ARCHITECT'S SUPPLEMENTAL INSTRUCTIONS

PROJECT - (name, address)	**SURGERY CENTER OF LEE'S SUMMIT** 1318 E. 104th St. Kansas City, MO 64131	**ARCHITECT'S SUPPLEMENTAL INSTRUCTION NO. - (6)**	**6**
OWNER -	**Hammes Partners** 1400 N. Water Street, Suite 500 Milwaukee, Wisconsin 53202	**DATE OF ISSUANCE -** April 29, 2024	
TO - (Contractor)	**JE Dunn Construction** 1001 Locust St Kansas City, MO 64106	**ARCHITECT -**	ACI Boland, Inc. 1710 Wyandotte Kansas City, MO 64108
CONTRACT DATED -		**ARCHITECT'S PROJECT NO. -**	3-22030

Description -
ASI 06 captures changes to the documents that support RFI responses, specifically regarding RFI 46. Which include modifications to the exterior canopies to conceal the dry-pipe sprinkler system. In addition, interior changes include mock-up changes to the OR's, Scope Processing area, Sterile Assembly, and Prep/Recovery Bays.

1 FIRST FLOOR HVAC PLAN - AREA A

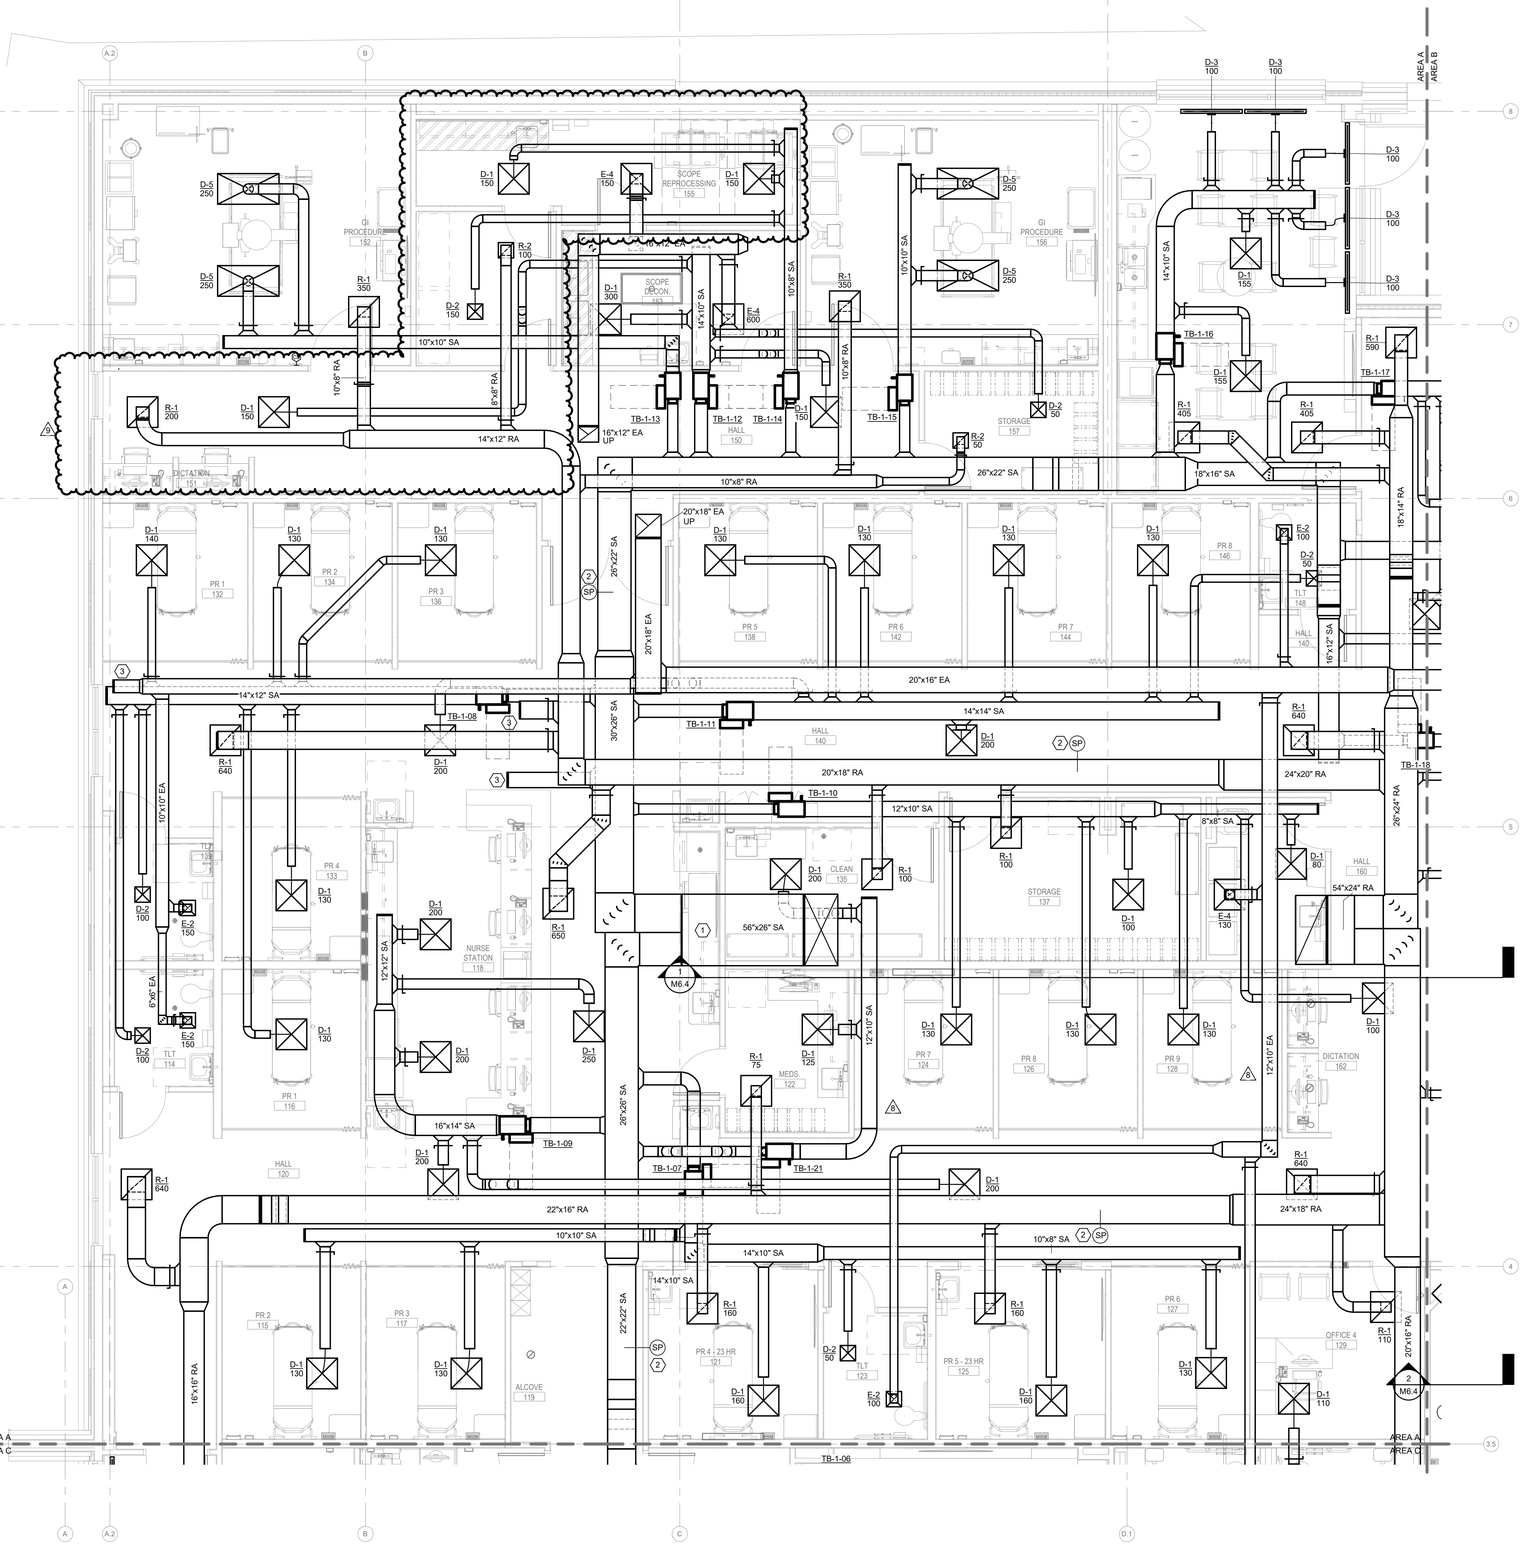
a. Revised duct & diffuser layout to match updated scope reprocessing area.

1 FIRST FLOOR HYDRONIC PLAN - AREA A
SCALE: 1/4" = 1'-0"

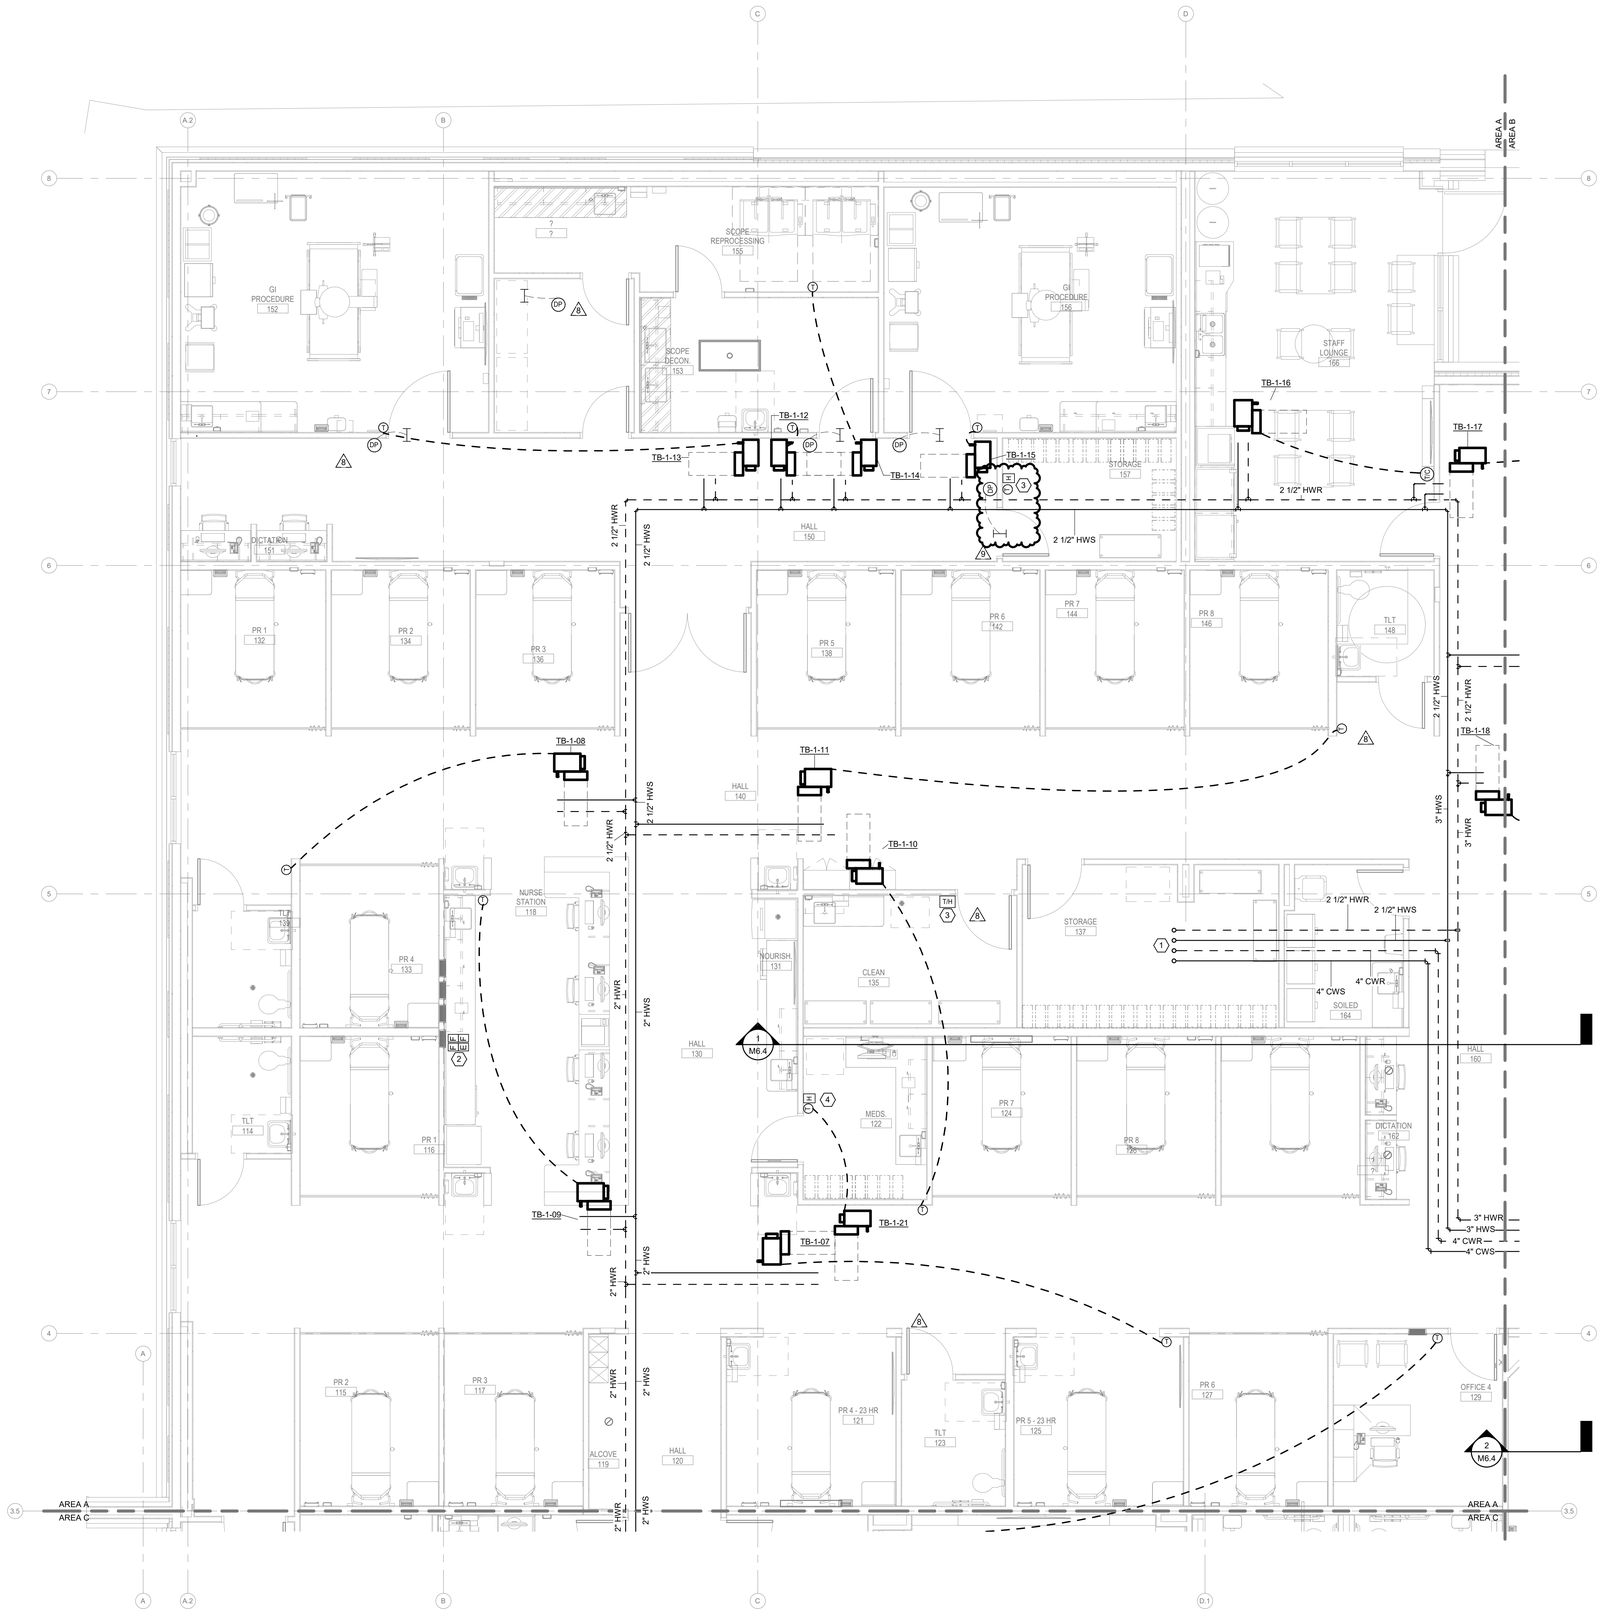
a. Temperature, humidity, and pressure monitor added to Storage 157 to match it's use as a sterile storage space.

1 FIRST FLOOR WATER AND GAS PLAN - AREA A
SCALE: 1/4" = 1'-0"

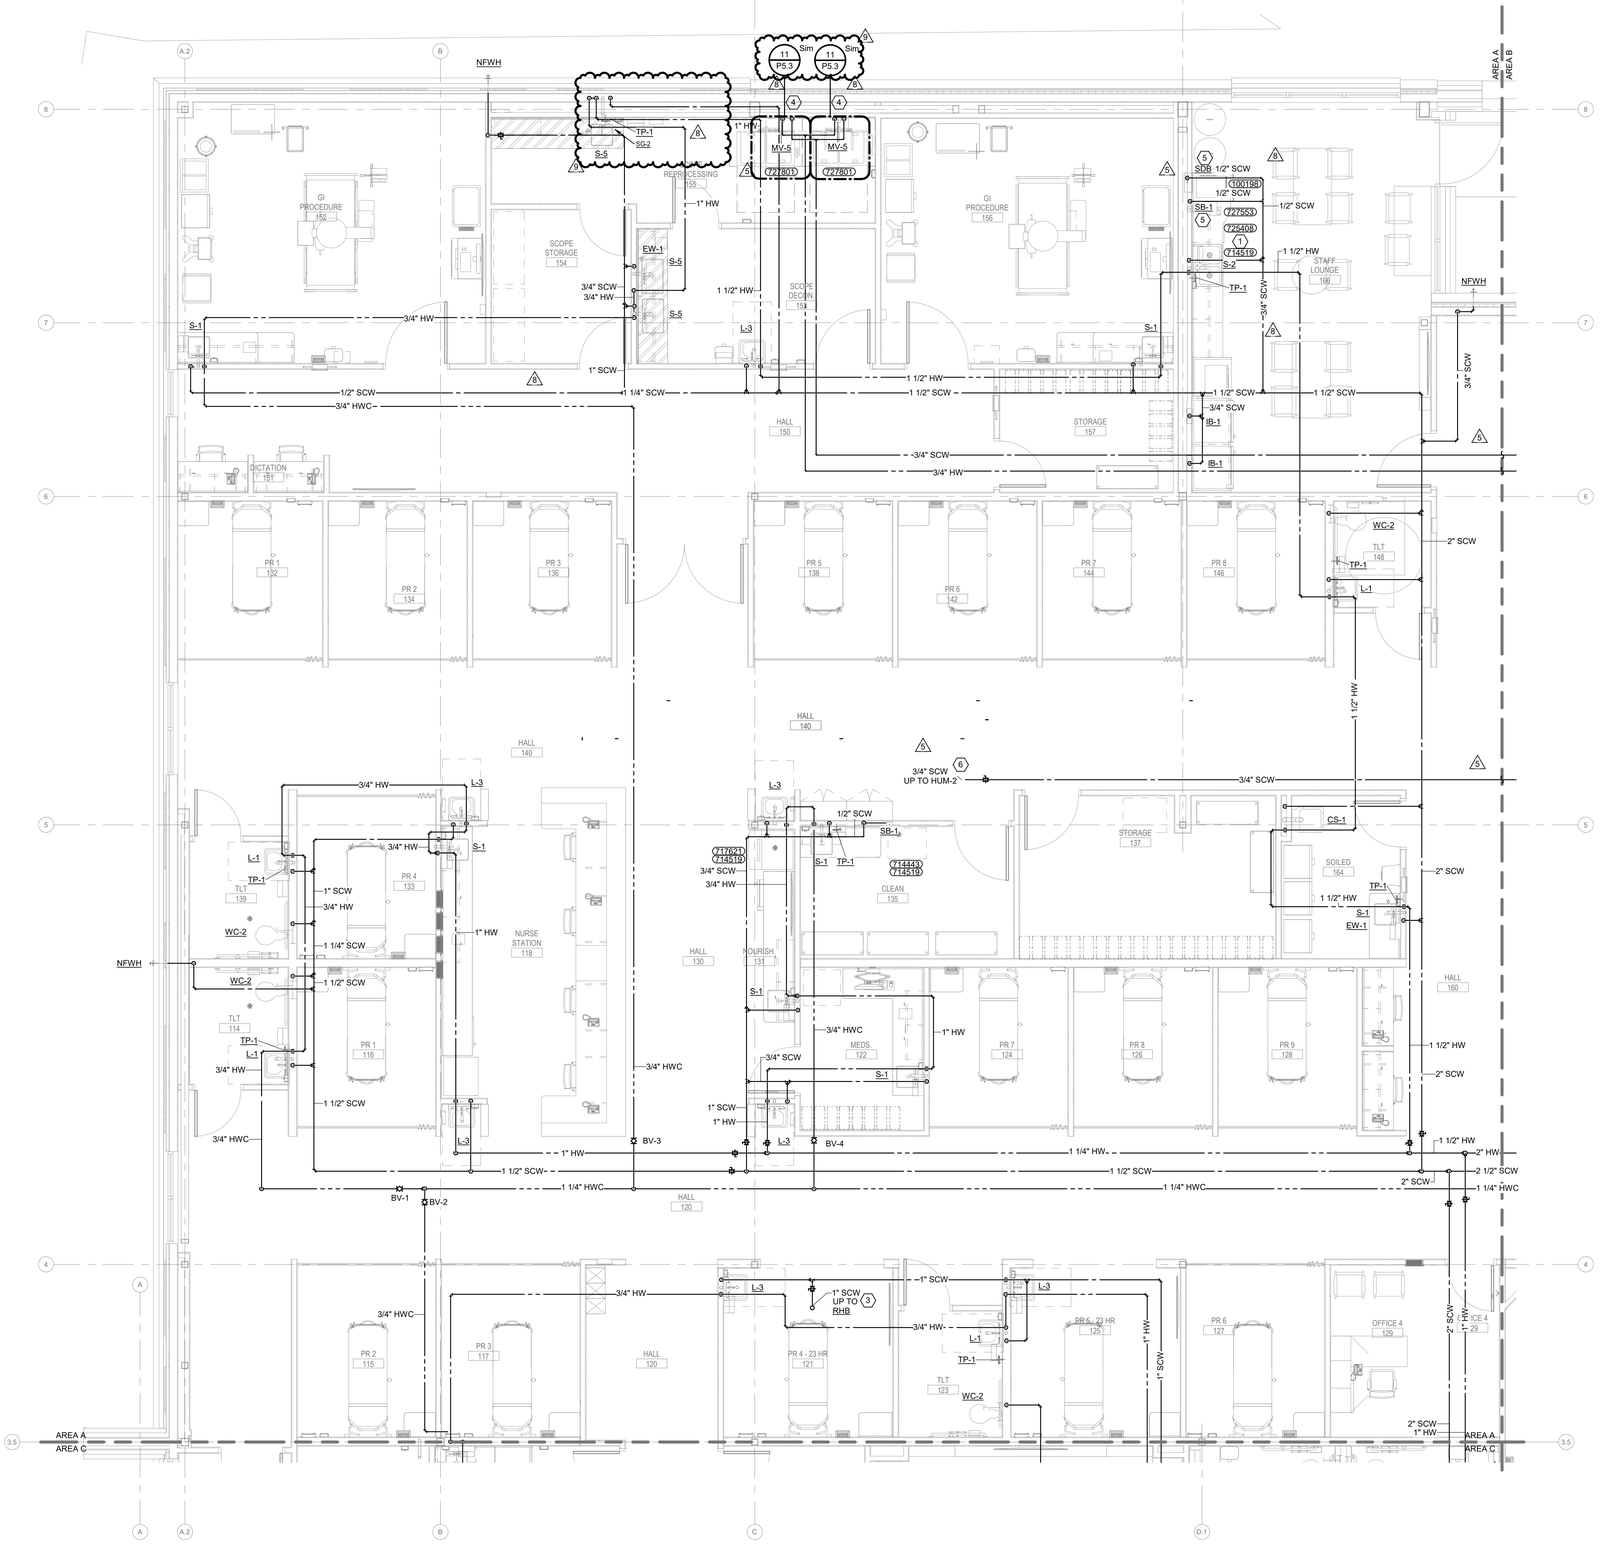
a. Updated note #4
b. Added SG-2 to left side of sink for air.
c. Added detail reference 11/P5.3 to the medivators.
d. Moved the water piping serving the moved sink.

1 FIRST FLOOR WATER AND GAS PLAN - AREA B
SCALE: 1/4" = 1'-0"

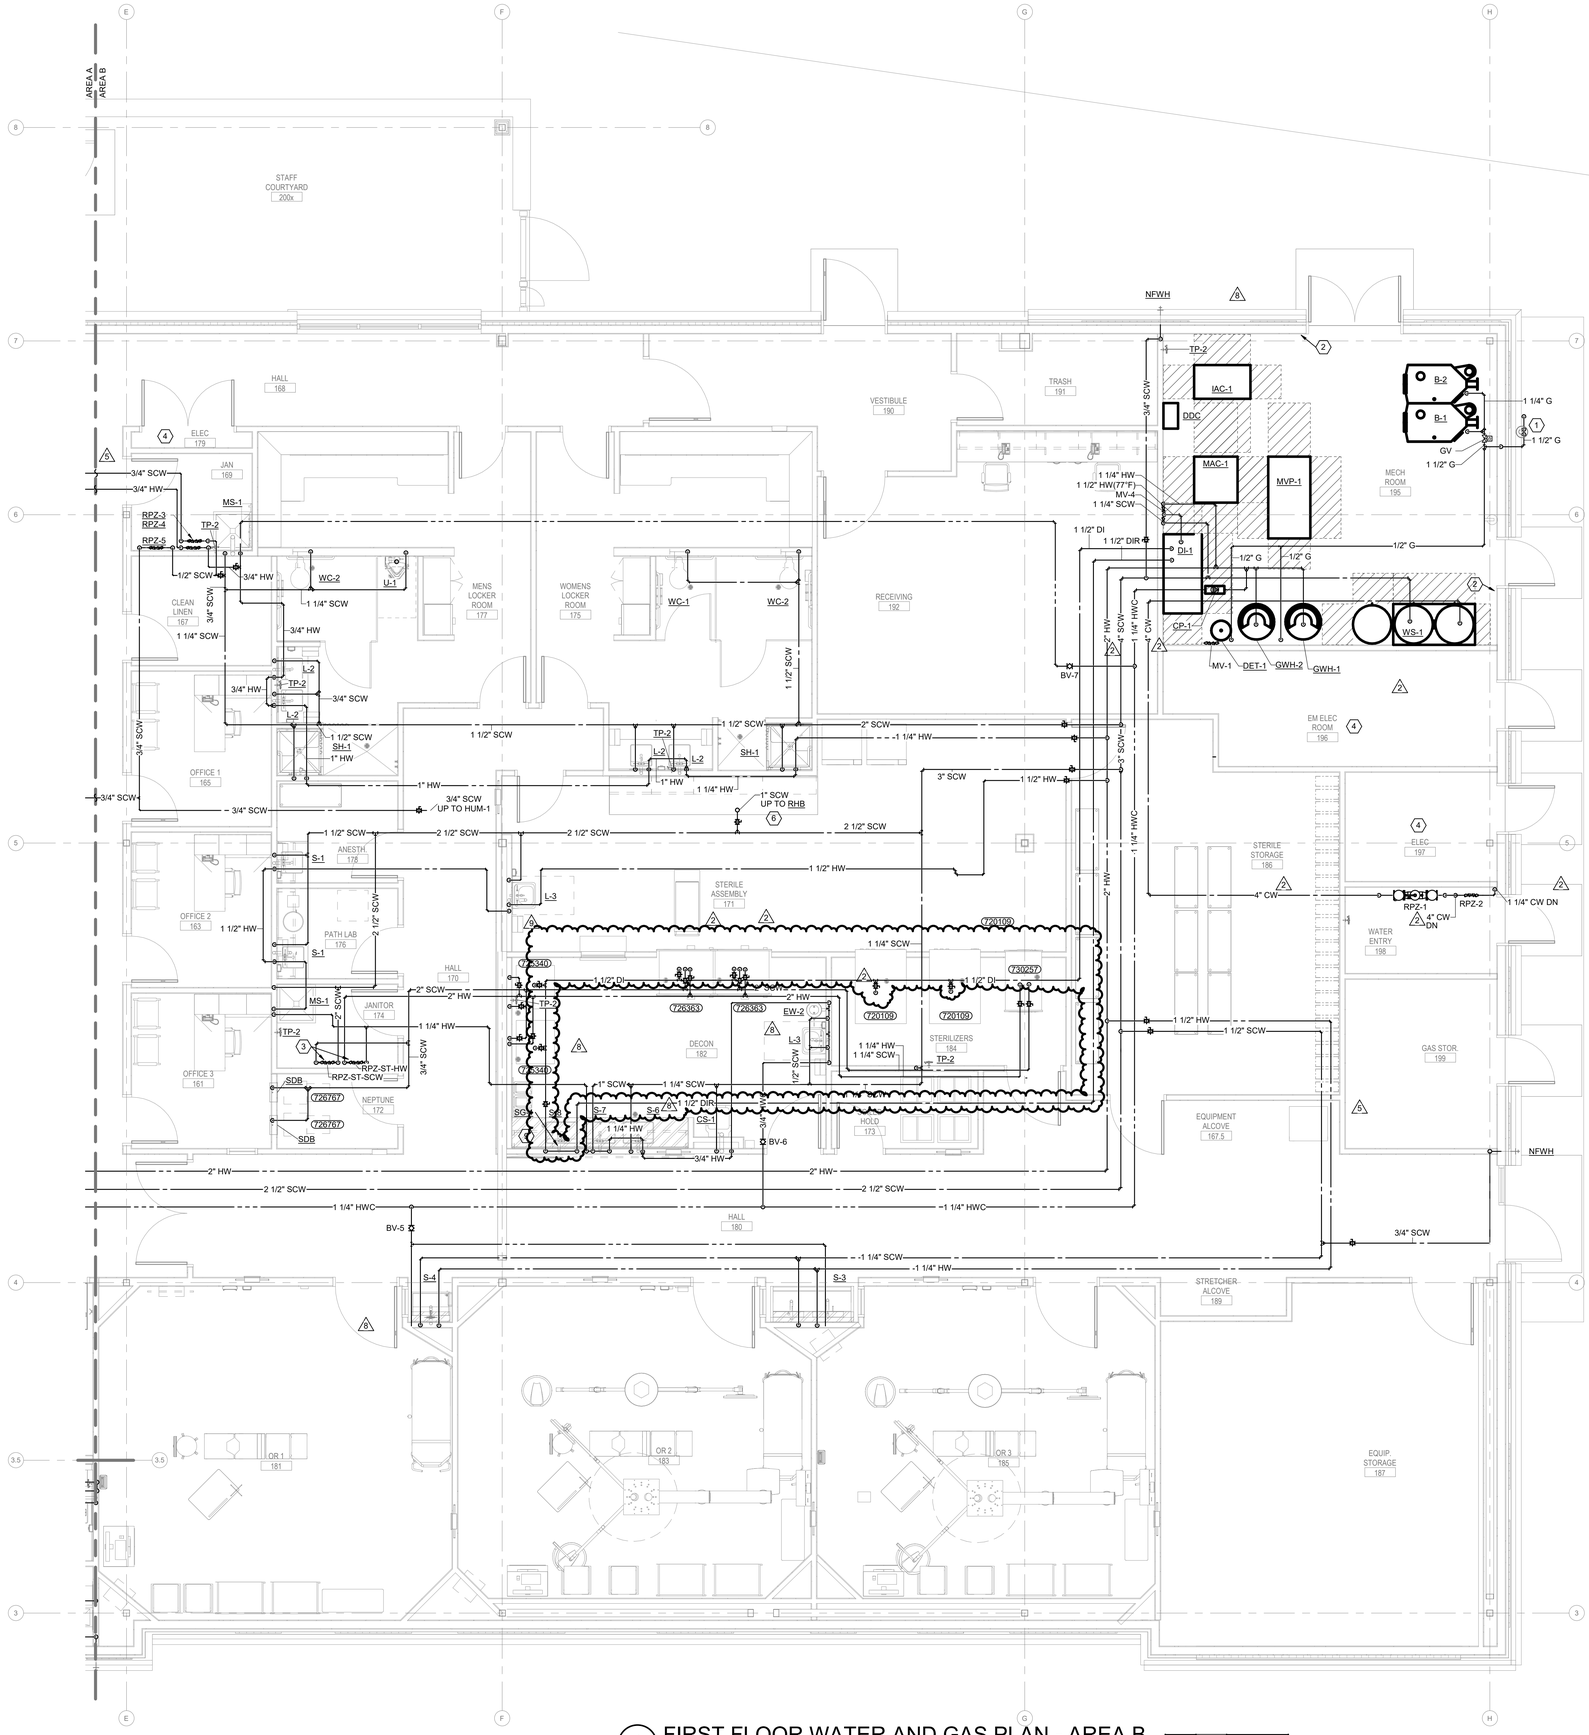
a. Updated DI water main routing per RFI 68.
